UNITED STATES PATENT AND TRADEMARK OFFICE

APPLICATION NO.	FILING DATE	FIRST NAMED INVENTOR	ATTORNEY DOCKET NO.	CONFIRMATION NO.
10/694,217	10/28/2003	Heum-Il Baek	053785-5013-01	2946

Office Action Summary	Application No. 10/694,217	Applicant(s) BAEK, HEUM-IL	
	Examiner Timothy L Rude	Art Unit 2883

DETAILED ACTION

FIG. 21

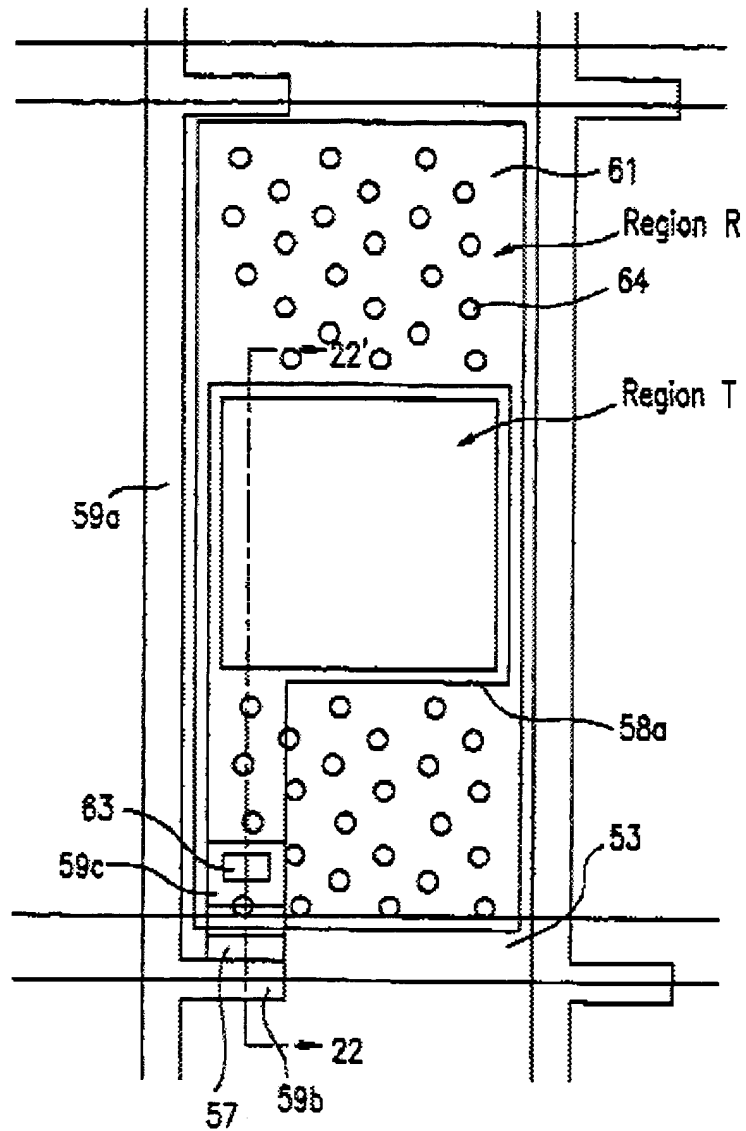
second example, col. 19, line 55 though col. 24, line 55, as shown in Figures 8A and 8B), a transflective display that reads on Applicant's species A, [Applicant's Figure 6] which is equivalent in most other regards to Examples 3 (regarding retarders applicable to Example 6) (col. 24, line 56 through col. 29, line 67) and 6 (regarding electrodes and other structure), (col. 47, line 50 through col. 51, line 25) a transmissive and reflective type (Applicant's transflective) (col. 8, lines 37-40) liquid crystal display, comprising:

substrate 1 (Applicant's upper) and substrate 2 (Applicant's lower), substrates facing into and spaced apart from each other, wherein the upper and lower substrates include a plurality of pixel regions (region R and region T) that display images;

FIG. 8A

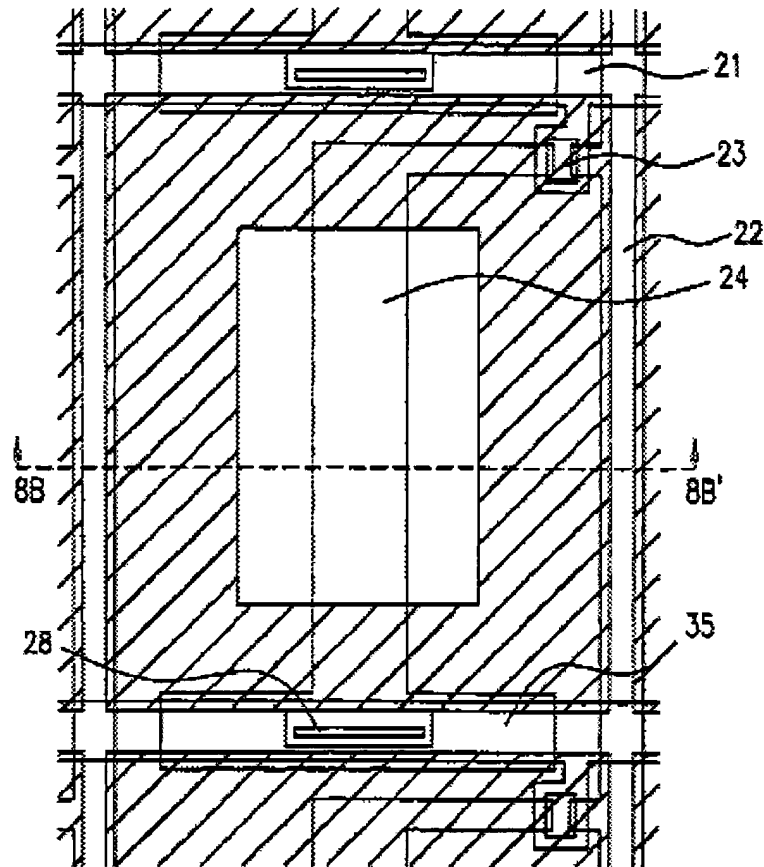
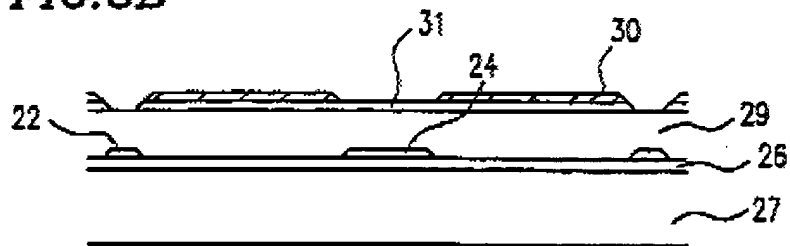
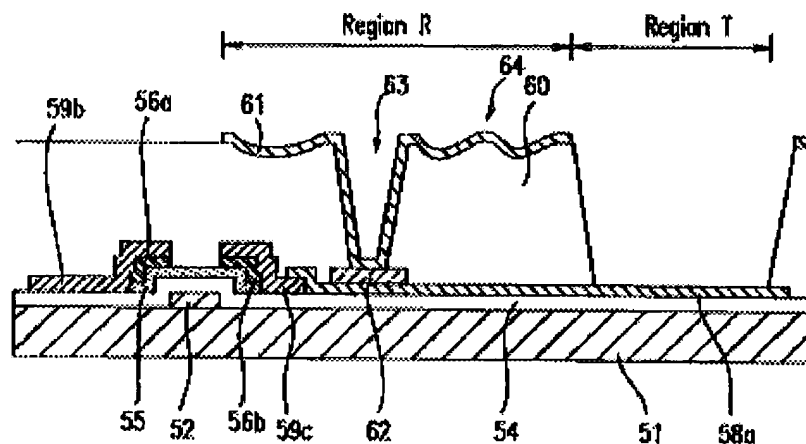
As to claims 1, 29, 30, and 32, Kubo discloses in his description of the preferred embodiments (embodiment 1, col. 8, line 20 through col. 19, line 54, and especially

Structures in Figures 8A and 8B are largely similar to Figure 22 with exception of the removal of material in Region T:

a liquid crystal layer, 5, interposed between the upper and lower substrates, wherein the liquid crystal layer has a first adjusted thickness (region R) to compensate a residual optical retardation of incident light caused by anchored liquid crystals near an alignment layer when a maximum operation voltage is applied;

a first upper retardation film, 11, over the upper substrate;

a second upper retardation film, 7, between the first upper retardation film

(interchangeable as indicated) and the upper substrate, wherein the second upper retardation film has a second adjusted thickness of compensating an optical retardation caused by the liquid crystal layer (col. 28, lines 32-53);

an upper polarizer, 6, on the first upper retardation film;

a transparent common electrode, 4, on a surface of the upper substrate facing into the lower substrate;

a pixel electrode over the lower substrate, wherein the pixel electrode corresponds to each pixel region, and the pixel electrode is divided into transparent, 58a, and reflective, 61, portions;

a second lower retardation film on the other surface of the lower substrate, wherein the second lower retardation film has a third adjusted thickness to compensate a residual optical retardation caused by the liquid crystal layer when a maximum operation voltage is applied;

a first lower retardation film, 12, under the second lower retardation film, 10, (interchangeable as indicated);

a lower polarizer, 9, under the first lower retardation film; and

a backlight device arranged adjacent to the lower polarizer (col. 13, lines 25-35). Note that Example 3 is a description of the retarder and polarizer arrangement applicable to Example 6 and is therefore not an obviousness type rejection.
